TO: Members of the MAG Standard Specifications and Details Committee

SUBJECT: MEETING NOTIFICATION AND TRANSMITTAL OF TENTATIVE AGENDA

MAG Standard Specifications and Details Committee
TENTATIVE AGENDA
February 1, 2012

STANDARD DETAIL

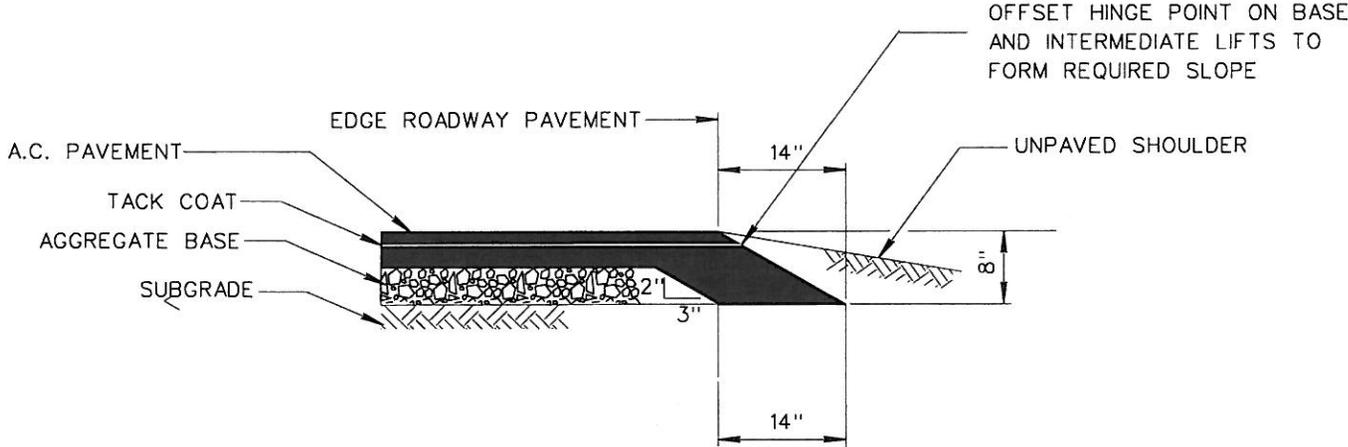
Add an Asphalt Pavement Safety Edge option to Detail 201. Bob Herz handed out a new detail drawing dated 12/11 that showed safety edge sections for both overlay and new pavement based on FHWA requirements. He noted that construction using these methods was difficult, and the county is still looking for ways to improve the details for better ease of construction; and was open for suggestions on how to do that. Rod Ramos asked if they used a shoe. Mr. Herz replied that they would be getting one as a loner to use on a future project, but have not tested it yet. He said they are currently using these details at the county until better ones are developed. Mr. Herz also noted that Chandler asked if the safety edge should be used in the alley details instead of the thickened edge. He doesn't think it should, because the purpose of the safety edge is to reduce overcorrection problems where speed is an issue. He said MCDOT does not require a safety edge on roads with speeds 40 mph or less. Peter Kandaris said the detail could be used for other applications. He said SRP uses a safety edge on access roads where vehicles frequently move on and off the road. Rod Ramos noted you can call out the detail as needed.

Add the following to Section 321:

321.8.8 Safety Edge: Prior to commencing paving operations that require construction of a safety edge, the Contractor shall submit for the Engineer's approval construction procedures to be used for placement and compaction of the safety edge.

The finished safety edge slope shall be planar and form a $30^{\circ} \pm 5^{\circ}$ angle with the horizontal plane. Due to the required final edge slope of the safety edge, compaction as required by sections 321.8.4 and 321.10 may not be attainable. When the approved procedures for placement and compaction of the safety edge are followed, the safety edge compaction shall be considered acceptable.

DETAIL NO. 360-1	 MARICOPA ASSOCIATION of GOVERNMENTS	STANDARD DETAIL ENGLISH	DRY BARREL FIRE HYDRANT INSTALLATION	REVISED 04-27-2011	DETAIL NO. 360-1
---------------------	---	----------------------------	---	-----------------------	---------------------

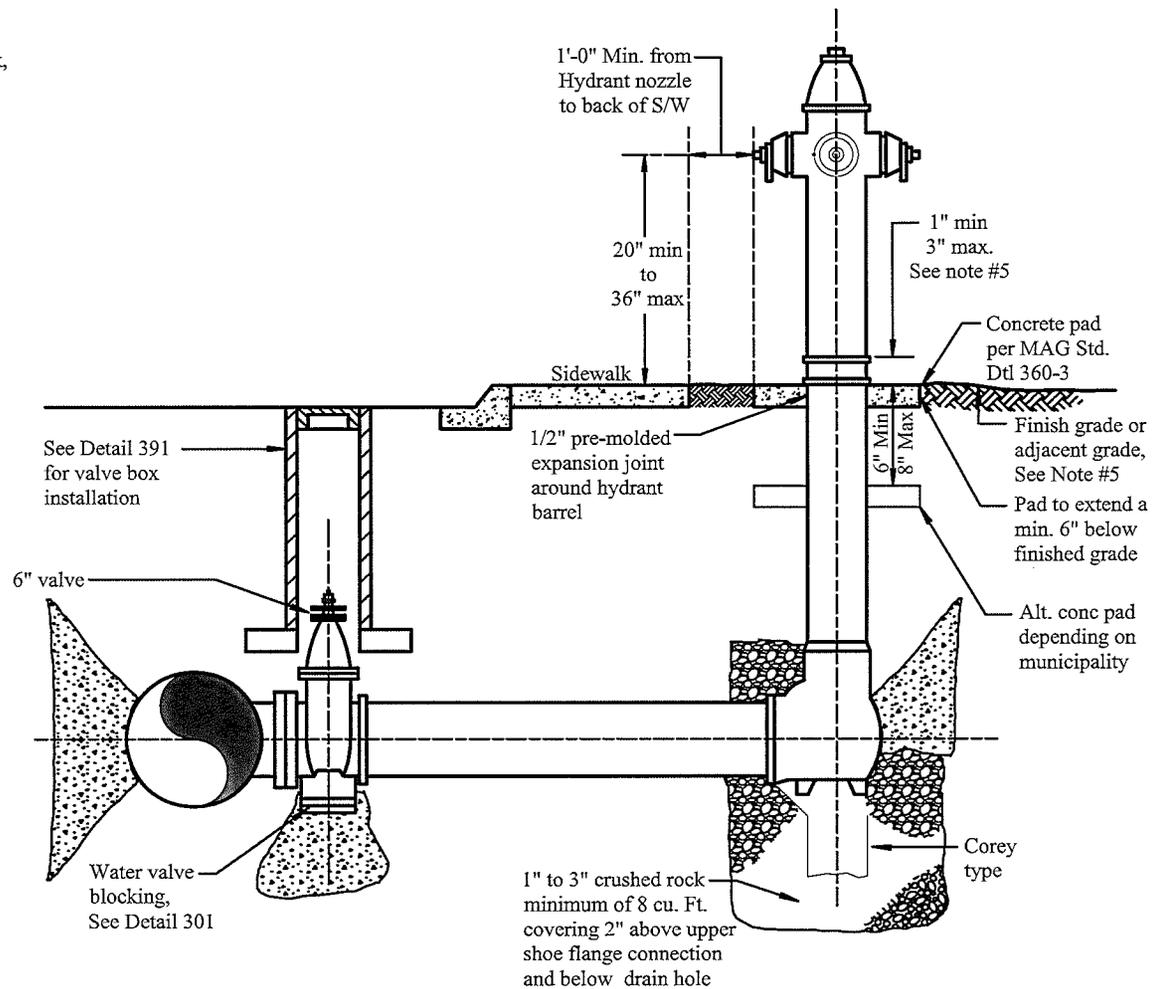
Update Detail 360-1, and add Wet Barrel Option (360-2) and Details (360-3). Scott Zipprich handed out the latest draft details presented during the October Water/Sewer Working Group meeting. In addition to the details, he prepared a draft letter to be forwarded to the agency fire departments so they could review the proposed details and provide feedback needed to revise them and have them accepted by the cities. He said the details added a wet barrel option, and tried to combine the requirements from current agency supplemental details. He gave the example of sheer block options shown on the details that could be specified by the agency depending upon their preference. The goal is to make relatively all-inclusive details that pull everyone's ideas together. Mr. Zipprich welcomed comments and said they would continue to be an item of discussion at the Water/Sewer Working Group meetings, and would like to have them approved this year.

Jim Badowich said some concerns of the fire departments are the clearance and setback requirements, which can vary from 36" to 7'. He also said hydrant threads were an issue, as well as the number of ports – typically 3 on commercial hydrants and 2 for residential area hydrants. Paul Nebeker said Chandler locks their hydrants. Mr. Zipprich said they decided to leave the lock off the main details, but an optional lock detail could be added later.

The MAG Water and Sewer Sub-Committee has revised the MAG Standard Detail 360 - Fire Hydrant Details and is requesting that all local Fire Departments and Engineering Departments review and make comments on the revised detail for the upcoming MAG Standard Specifications and Details Committee in 2012.

DETAIL NO. 360-2	 MARICOPA ASSOCIATION of GOVERNMENTS	STANDARD DETAIL ENGLISH	WET BARREL FIRE HYDRANT INSTALLATION	REVISED 04-27-2011	DETAIL NO. 360-2
---------------------	---	----------------------------	---	-----------------------	---------------------

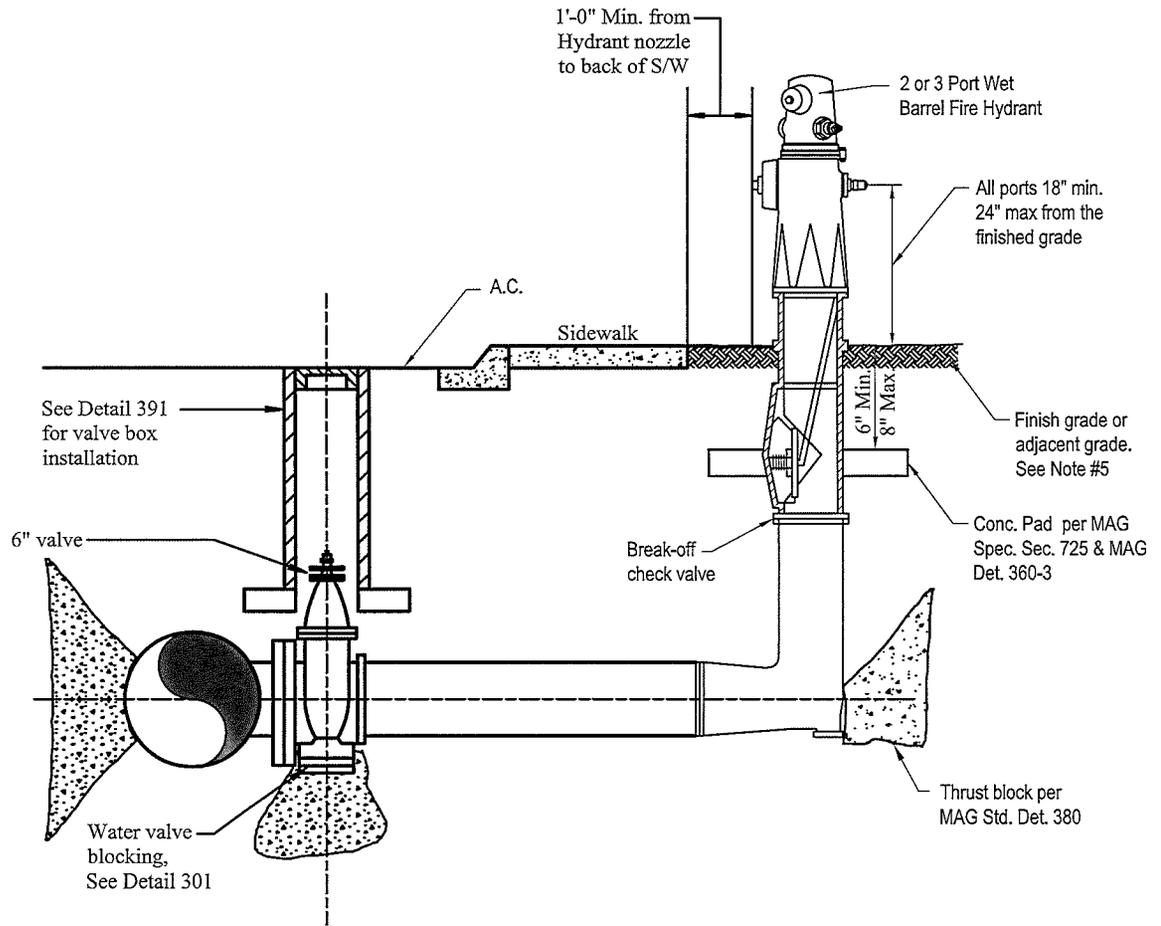
12. See Detail 360-3 for Concrete Pad.
13. The hydrant shall have 2- 2½" port and 1- 4½" port (industrial or commercial).
14. The hydrant shall have 1- 2½" port and 1- 4½" port (residential).
